Inspection Report Minerals Regulatory Program Report Date: November 24, 2004

Mine Name: Red Chief Permit number: S/015/083 **Operator or Permittee Name:** Inspection Date: November 18, 2004 Quality Building Stone Permittee Mailing Address: 993 West 14730 South, Bluffdale, UT 84065 Weather: Mostly clear, 40's **Inspection Start Time: 2:20 PM Inspector(s)**: Paul Baker **Inspection End Time:** 2:35 PM Other Participants: None Site location/Area Inspected (i.e. Pit #): Entire area Permit Status: Inactive Surface Ownership: SITLA **Current Acreages:** Mineral Ownership: SITLA Total Permitted (Bonded): 4 Mineral Mined: Stone Total Disturbed: Exact acreage not known; about 1-Type of Mine: Surface 2 acres disturbed

Photographs S/015/083, Red Chief, Quality Building Stone

Photo 2. Drainage crossing. Note the large rock restricting access.

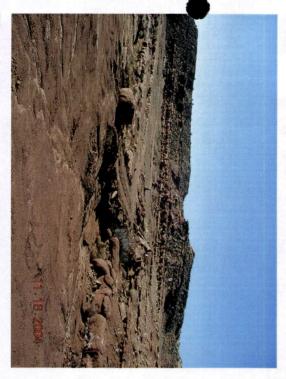
Photo 2 shows a small drainage that was blocked to create access to the main part of the quarry. If the quarry was going to remain for an extended time, I would recommend a culvert be placed in this drainage.
